subject Hamilton Wetlands Post-Construction As-Built Survey Review – Breach and Completion Contract.

This memorandum presents the ESA's post-construction assessment of the Hamilton Wetland Restoration Project following the Breach and Completion Contract.

Hamilton - Post Construction . 1764.10
Figure 13
 Tidal Panne February 2014
 Post-Construction Point Survey
 vs Design Grade

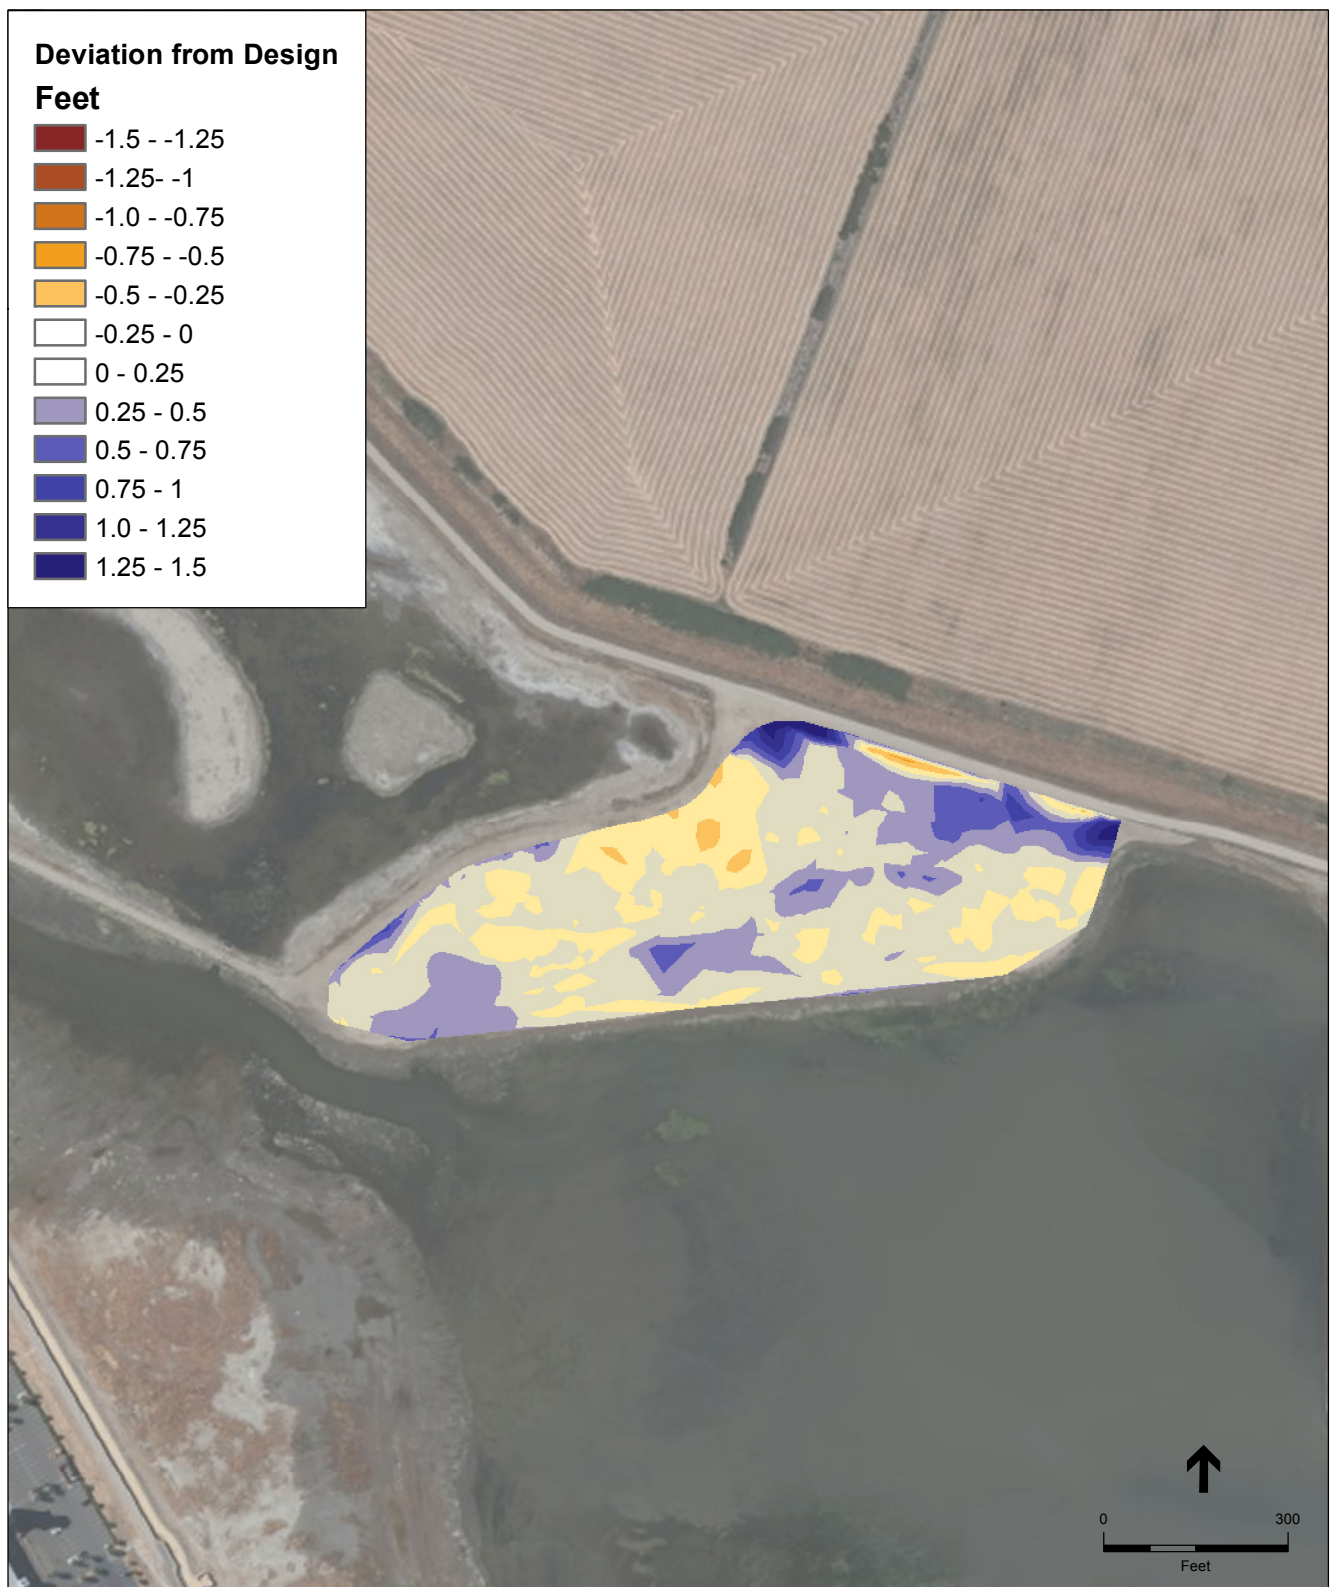
Figure 12 shows the as-built surveys for the Tidal Pannes including contours from the aerial photogrammetry, spot elevations collected post construction, and spot elevations along the NSW berm collected by ESA. Figure 13 shows the difference between the design grade and the post-construction ground survey. Figure 14 shows the difference between the design grade and the post-construction aerial photogrammetry. Figure 15 shows typical cross sections of the Tidal Pannes. Note that the point survey data show close agreement to the design grades, while the aerial photogrammetry survey shows larger deviations from the design grade.

FIGURE 19
ITBB 25 & 26 Cross Sections

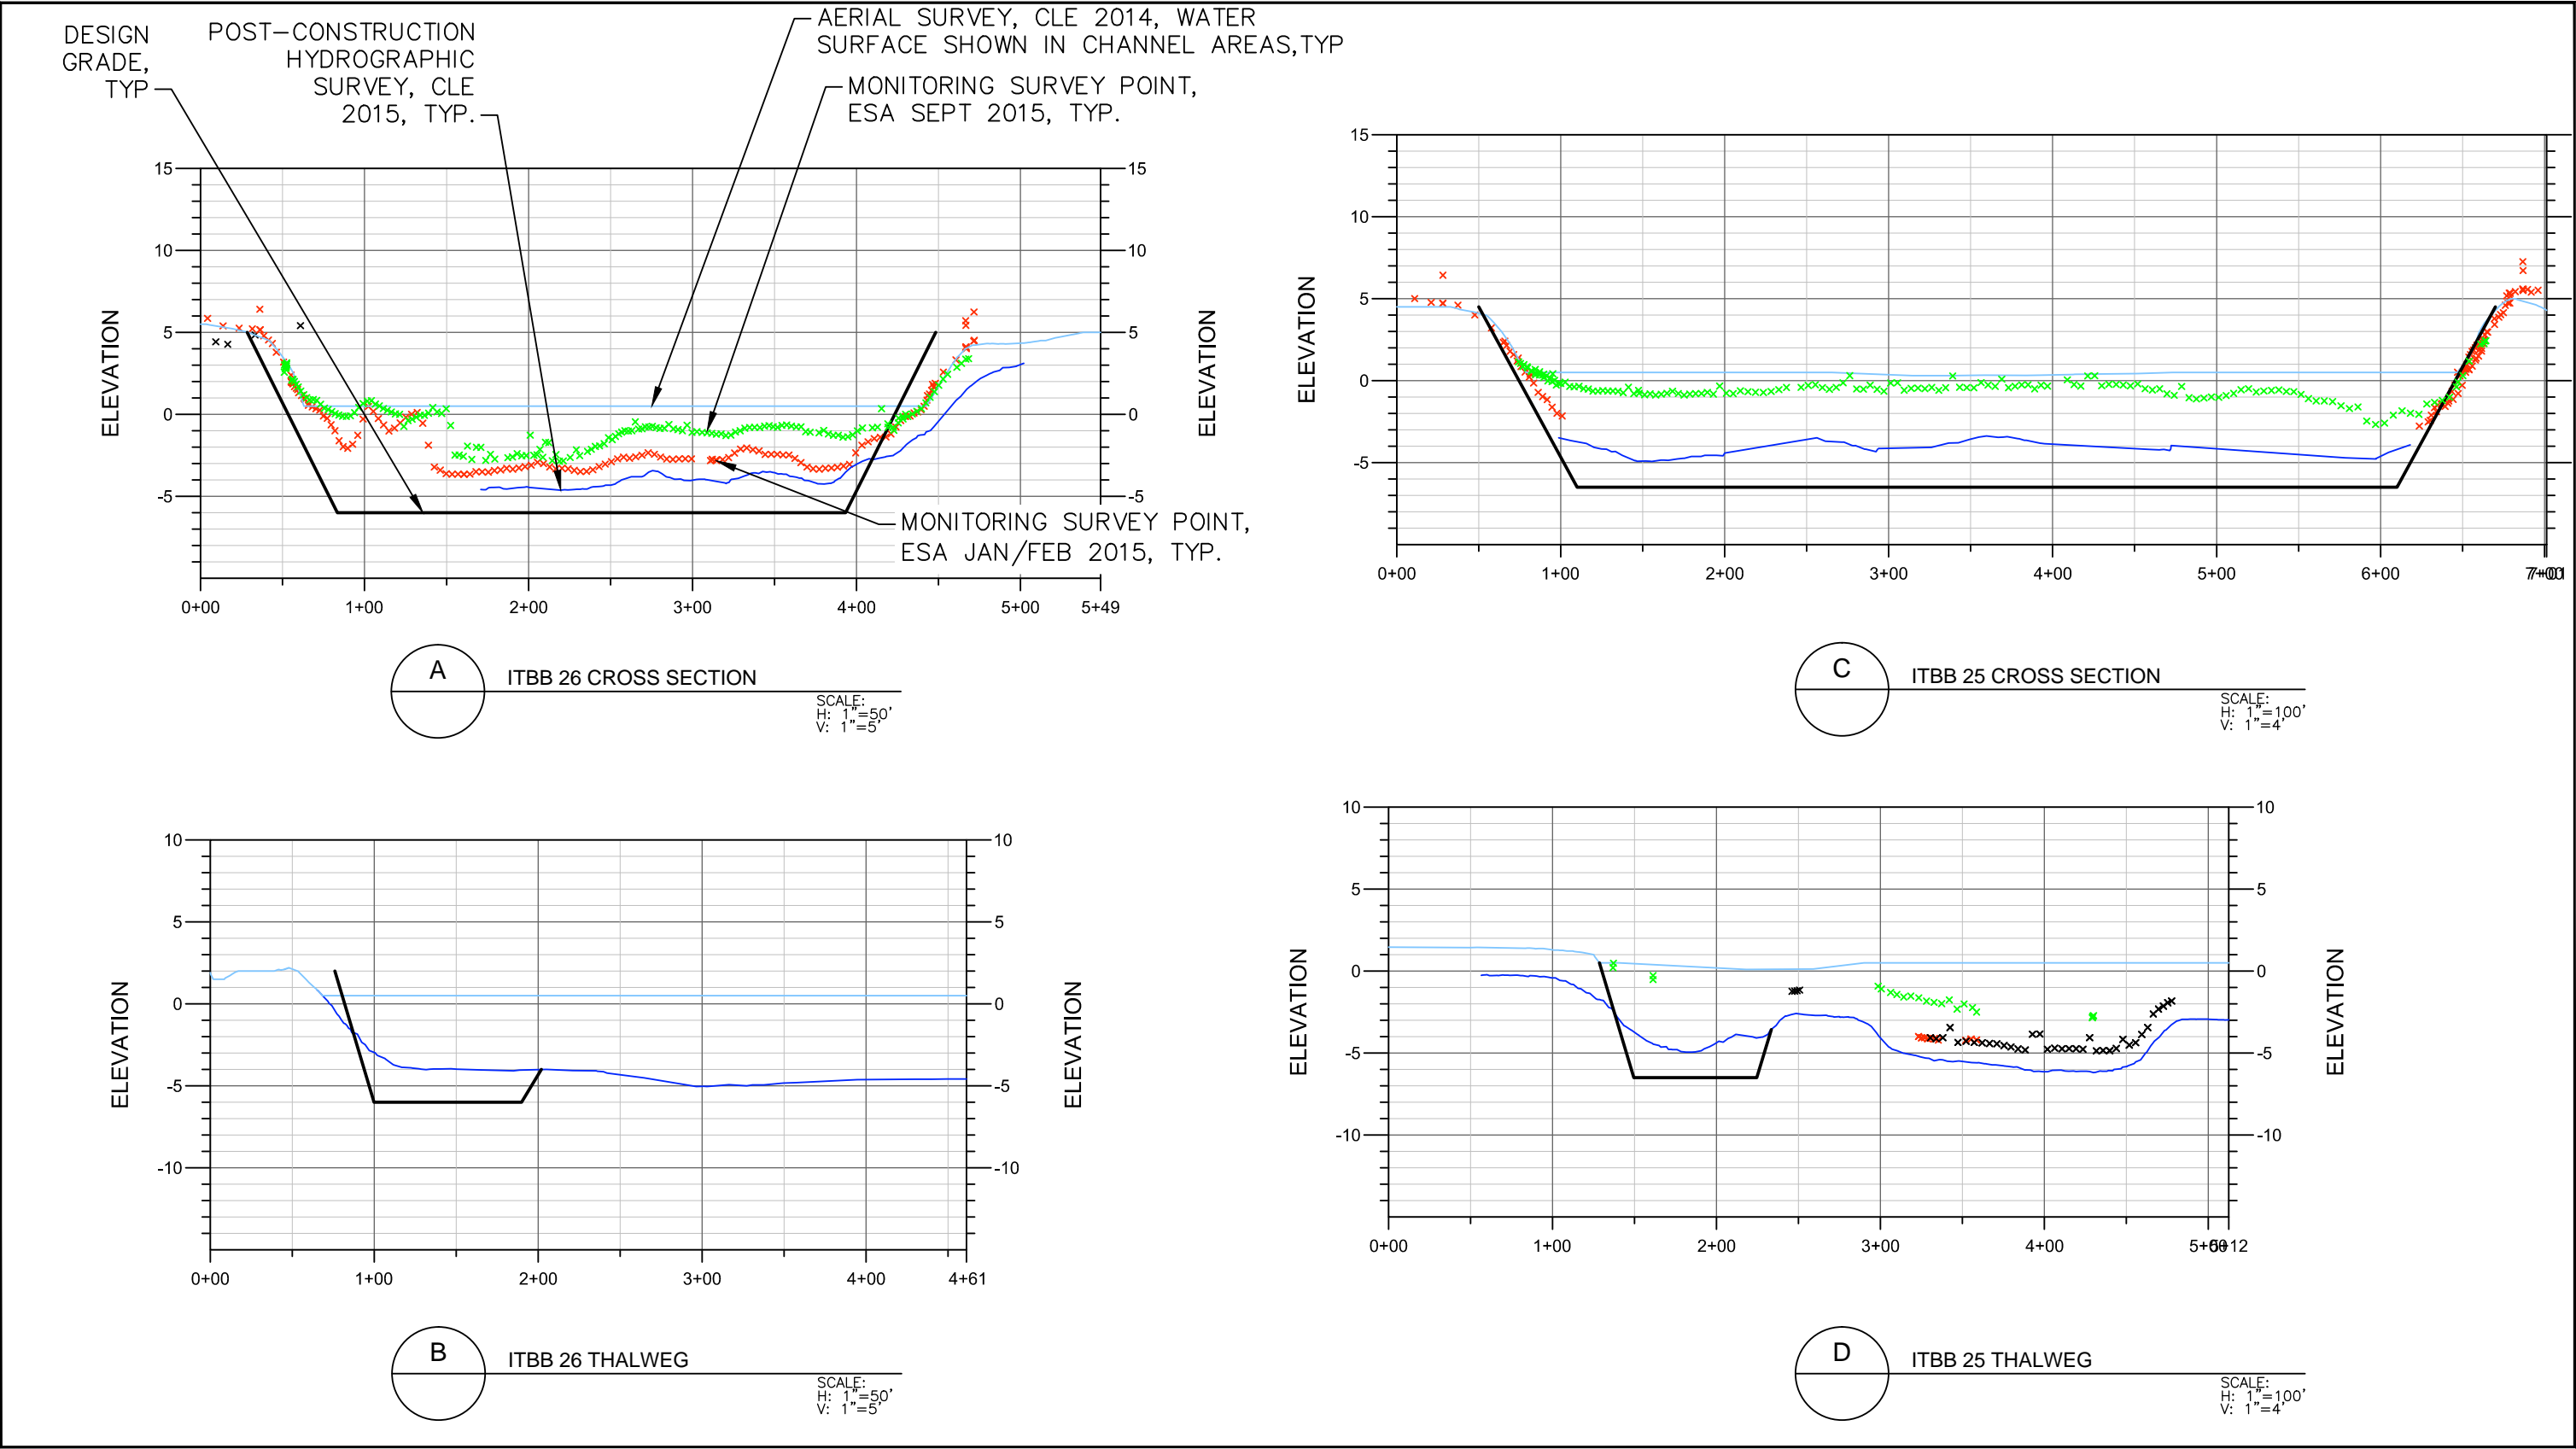
Figure 18 shows a plan view of ITBB 25 and 26, showing the location of the available survey datasets at these two breaches, including the CLE Hydrographic Survey from early 2015 (shown as contours) and the ESA Monitoring Surveys, both conducted in Jan/Feb 2015 and Sept 2015. Figure 19 shows cross sections and profiles for these two breaches. Figure 19 also shows channels ESB 25 and 26 excavated within the expanded settling basin. Figures 20 and 21 show the plan view of ITBB 14, and a cross section and profile for this breach.

Table 3 summarizes the findings of the post-construction surveys. Both the CLE and ESA surveys show excavated grades higher than the design grade. The bottom width of all three intertidal berm breaches approximately matches the design width, however the excavated depths were all above tolerance at the time of surveys. The excavated depths ranged from 1.5 to 3 feet above design grades at ITTB 25, 1.5 to 2 feet above design grade at ITTB 26, and 1 to 2.5 feet above design at ITTB 14. Since the surveys were performed several months following construction, it is not clear if these intertidal berm breaches were under-excavated at the time of construction or if the soft dredge material migrated into the excavated breach. The more recent monitoring surveys conducted in the fall of 2015 suggest that these intertidal berm breaches may be filling with poorly consolidated sediment from the adjacent mudflats, these findings will be discussed further in the Year-1 monitoring report. The evolution of these breaches will continue to be monitored.

As-Built Survey Data - Outboard Levee Breach
Cross Sections 1

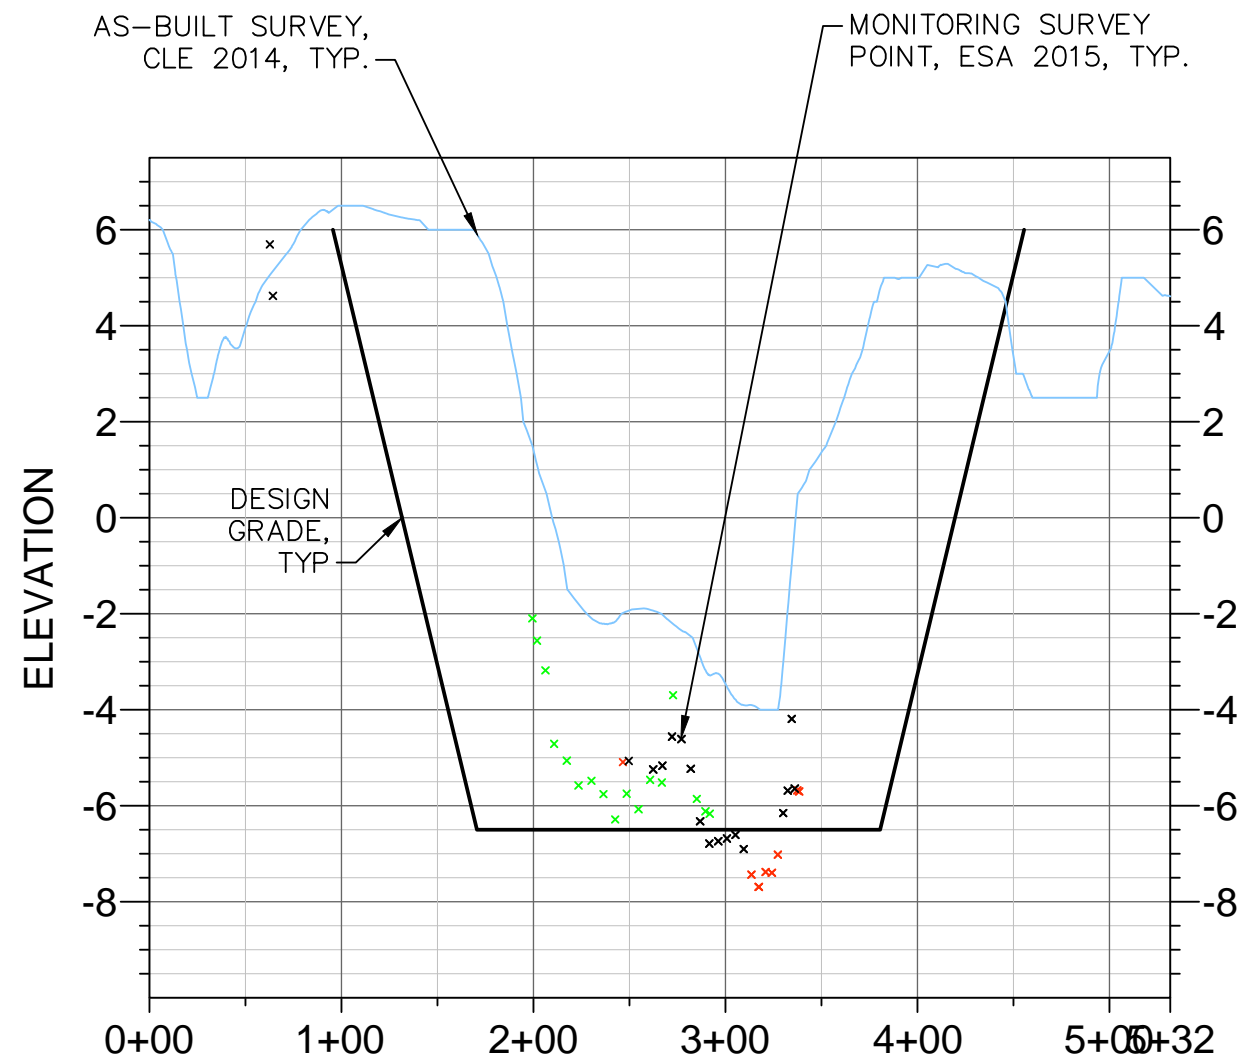
The CLE survey indicates that breach excavated through the levee is significantly shallower than specified in the design at cross sections A, B and C; and narrower than specified at cross section C. However, survey data collected by ESA as part of the Year-0 monitoring show depths 2 to 4 feet deeper than the as-built survey at cross sections A and C, which appear to show that the breach was excavated to design grades within tolerance. It is not clear why there is a 2 to 4 foot difference between the as-built survey and the Year-0 Monitoring survey at these cross sections.

- *The Outboard Levee Breach and outer Access Channel dimensions are under-excavated:* The reduced dimensions of the main breach may restrict tidal flows into and out of the restored site, reducing both the tidal prism and the tide range. The reduced tidal prism may limit sediment transport into the site, decreasing the rate of accretion on the marsh plain. The reduced tide range may inhibit the establishment of marsh vegetation by reducing the extent of intertidal area within the site. In addition, the Access Channel was under-excavated and is shallower than design which can limit low tide drainage. It is expected that over time the breach will scour and enlarge, however the likely rate of scour is unknown and will be limited by the reduced breach excavation.
